**Subject:** Red Hill Shaft Flow Optimization Study  
Red Hill Bulk Fuel Storage Facility

November 1, 2023

SUBJECT: Review of the Department of the Navy's (Navy's) Proposal to Reduce  
Red Hill Shaft (RHS) Pumping Rate

Figure 1. Map showing the estimated chloride concentration in recharge and the measured groundwater chloride concentrations.

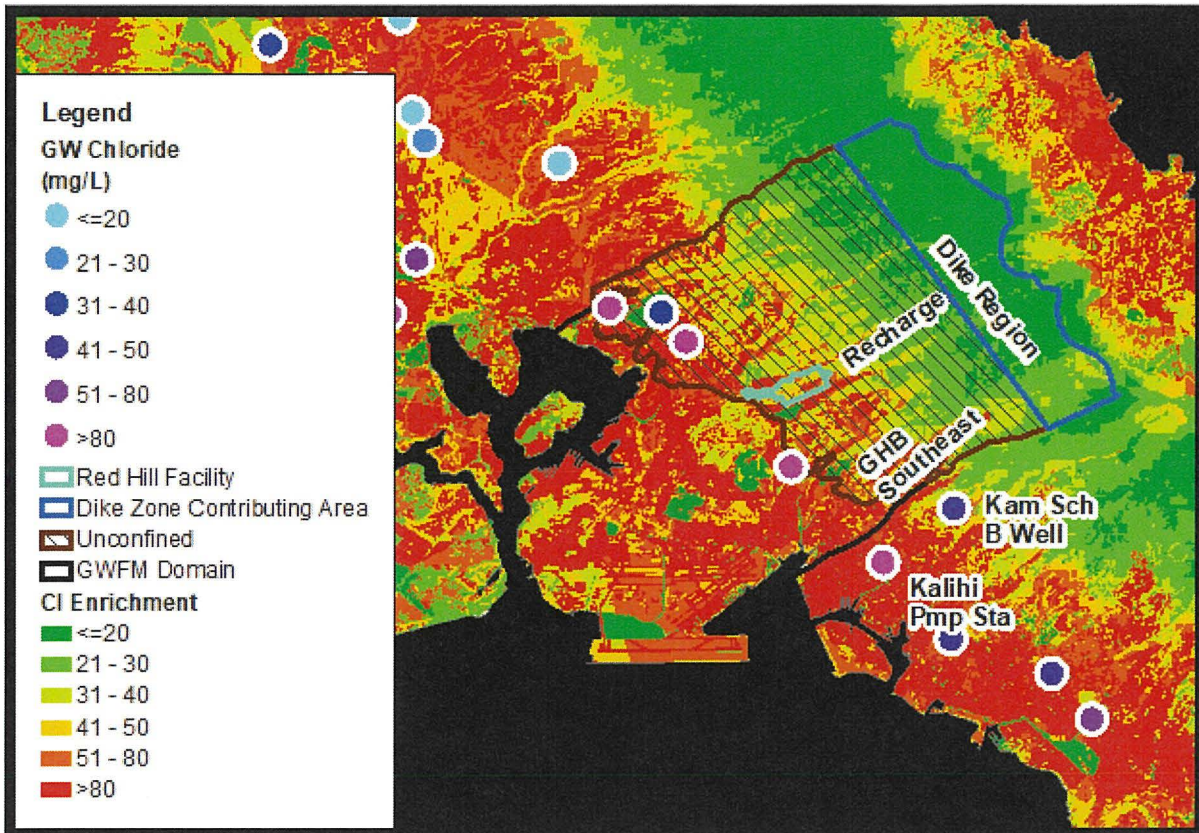
To perform a general assessment how appropriate the Navy's selected chloride concentrations are, I performed some independent analysis. Using the USGS published recharge coverage for Oahu (Engott, 2017) and the Navy's CMB equation used in Section 4.4.6 of the BAGWFM Report (shown below), I mapped the recharge chloride concentration for the Moanalua/Red Hill/Halawa area.

The result is shown graphically in Figure 1 and the discussion below evaluates the chloride concentrations that Navy computed (Table 4-8 of the BAGWFM Report). For the Rainfall Recharge boundary, the Navy only considered recharge within the Red Hill Facility. This is incorrect because recharge upslope from the Red Hill Facility, but within the model domain boundary, should also be considered. The chloride concentration in most of the upslope recharge is too low to support the Navy computed Rainfall Recharge chloride concentration of 45 mg/L. Considering the Dike Region boundary, the contributing area is between the northeast model boundary and inland boundary of the Honolulu and Pearl Harbor aquifers. This area is enclosed with the blue bordered polygon in Figure 1. Nearly all the chloride in this area has a concentration less than 20 mg/L, which is significantly less than 30 mg/L used by the Navy for this boundary condition. No rationale is given in the BAGWFM Report as to why a chloride concentration of 40 mg/L was chosen for the GHB Southeast Boundary. The chloride concentration for this boundary can be estimated using available groundwater data. Figure 1 shows that the USGS NAWQA Study (Hunt, 2004) sampled two wells near the GHB Southeast Boundary, the Kamehameha School B Well with a chloride concentration of 41.1 mg/L and the Kalihi Pump Station with a chloride concentration of 80.9 mg/L. Using the available data, the most appropriate chloride concentration for the GHB Southeast Boundary would be 60 mg/L, an average of the two wells' chloride concentrations.

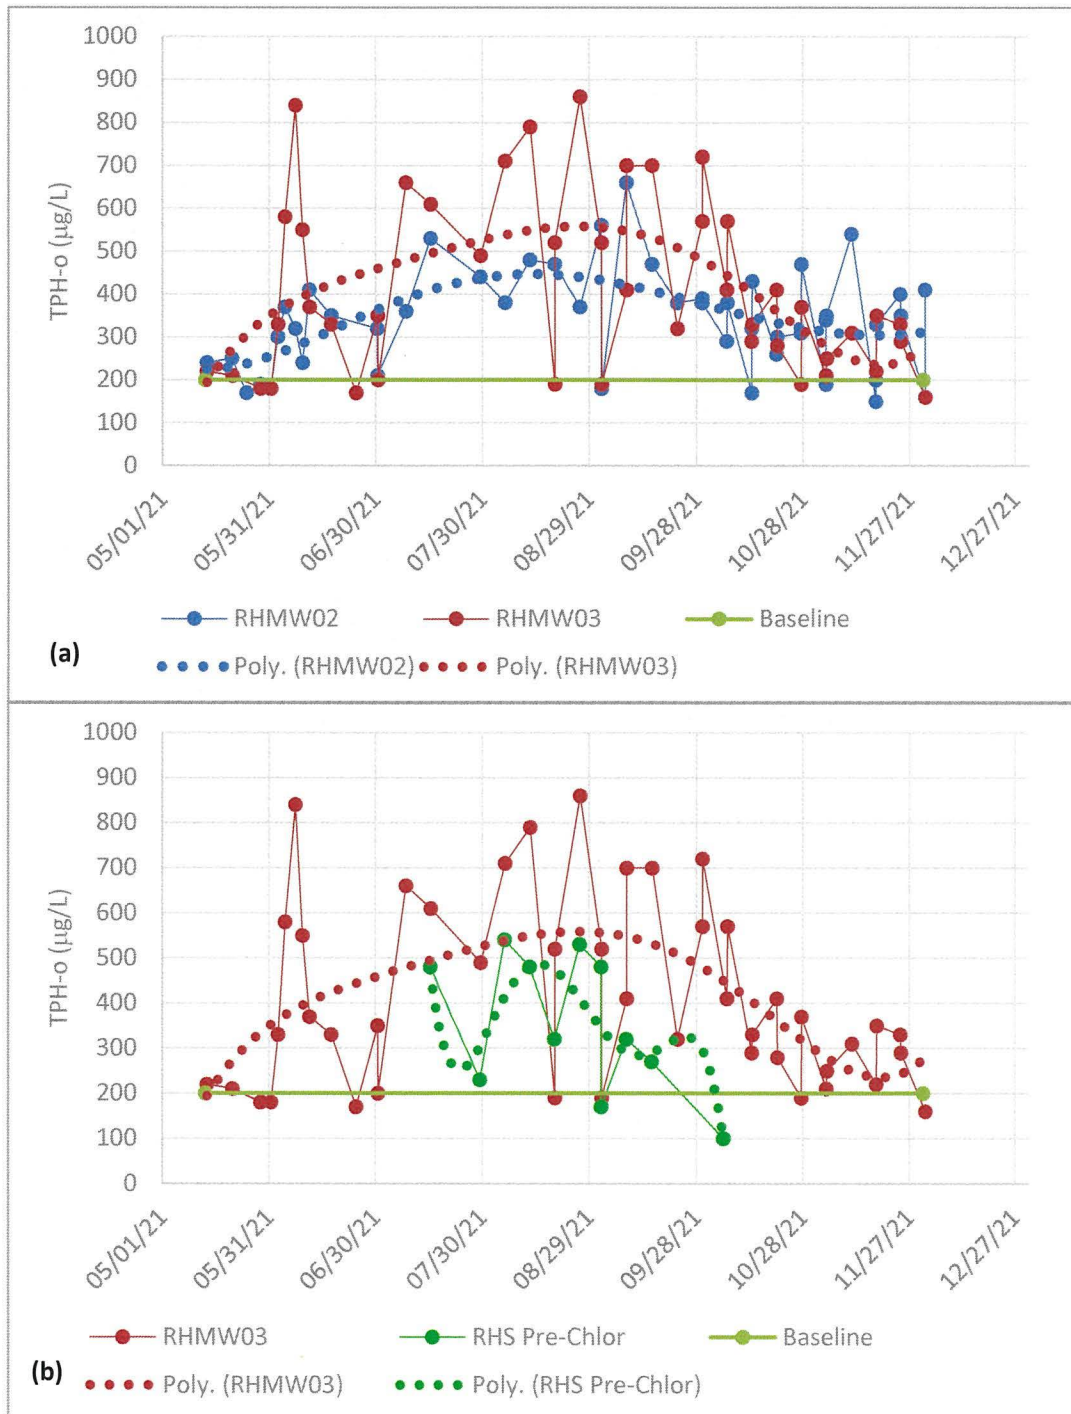
**TPH-o from the May 2021 Release:** In Section 4.5.5 the Navy states that “TPH-o analytical data collected after the May 2021 release are considered. These data provide a line of evidence that anisotropy of the aquifer is high enough to create flow conditions generally along dip rather than in the direction of the hydraulic gradients.” The Navy proposes that the TPH-o results shows a plume migrating from the spill site near Tanks 18 through 20 down the axis of the Red Hill Ridge then being captured by the Red Hill Shaft Pumps. Table 4-10 in the Final Report lists wells considered, date of first detection, and computed average groundwater velocity. Charts 4-2 through 4-7 show the TPH-o traces for RHMW03, RHMW02, RHMW01R, RHMW05, RHMW2254-01, and the RHS pre-chlorination spigot. There are some serious problems with this analysis. First, the spill occurred over 100 ft above the water table so unsaturated zone transport needs to be considered when estimating groundwater flow velocities. Some of the wells used for this analysis should be removed due to insufficient data. RHMW01R has no indication of TPH-o that exceeds background except for an isolated result in November, well after the stated first detection at the RHS pre-chlorination spigot. The first May 2021 post-release sample collected at RHMW05 was on September 29, 2021, again well after the plume had become evident at the RHS pre-chlorination spigot. Since no sample was taken earlier, it is inappropriate to compute a groundwater velocity using RHMW05 data. RHMW2254-01 has no detections above background. This leaves us with RHMW03, RHMW02, and the RHS pre-chlorination spigot to evaluate the plume migration characteristics. In Figure 2a and b, I plotted the TPH-o data versus time. Figure 2a plots the TPH-o data for RHMW03 and RHMW02. Figure 2b plots the TPH-o data for RHMW03 and the RHS pre-chlorination spigot. For both graphs an empirical best fit line was generated. This simple exercise shows there is no temporal offset in the plumes at these wells with the plume traces peaking at approximately the same time at all three locations. Contrary to the Navy’s conclusions, the TPH-o data following the May 2021 release do not support a saturated zone plume migration down the axis of the Red Hill Ridge and don’t provide physical evidence supporting the very high horizontal anisotropy that is needed for the particle track analysis to indicate capture.

Figure 3. Graphs of wells with elevated TPH-d concentrations that correlate with the flow optimization study test periods.

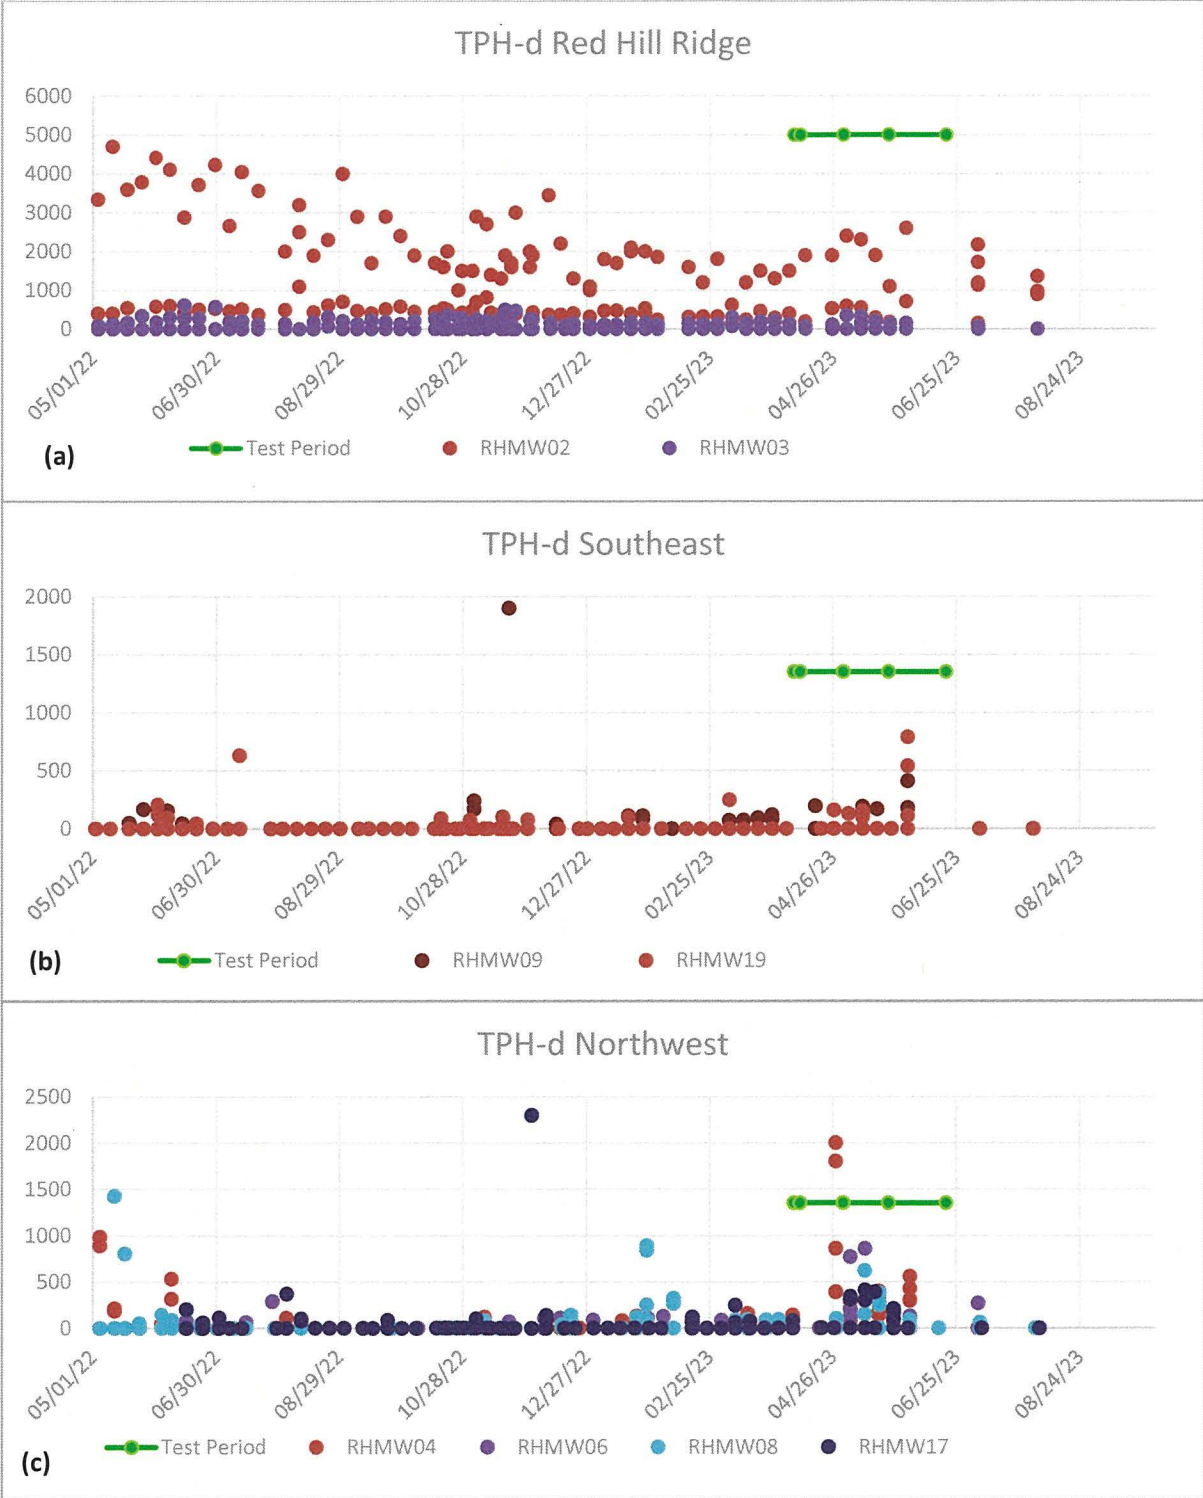
does not evaluate potential trends or increased concentrations. DOH downloaded the data from the Environmental Data Management System (EDMS) and plotted the TPH-d results for a period from May 2022 through early August 2023. We observed that several wells showed elevated TPH-d detections during the Flow Optimization Test period. Figures 3a through 3c graph the TPH-d data for the wells that showed elevated concentrations. The wells are segregated into three groups, wells in the Red Hill Ridge line (3a), southeast region of the Red Hill Facility (3b), and the northwest regions of the Red Hill Facility (3c). Elevated TPH-d concentrations were most prevalent in the northwest region wells. Prior to any change in RHS pumping rates, the potential relationship between groundwater contaminants and the various pumping rates needs to be further evaluated, or else additional monitoring will be needed to identify potential contaminant migration during a reduction in the average pumping rate.
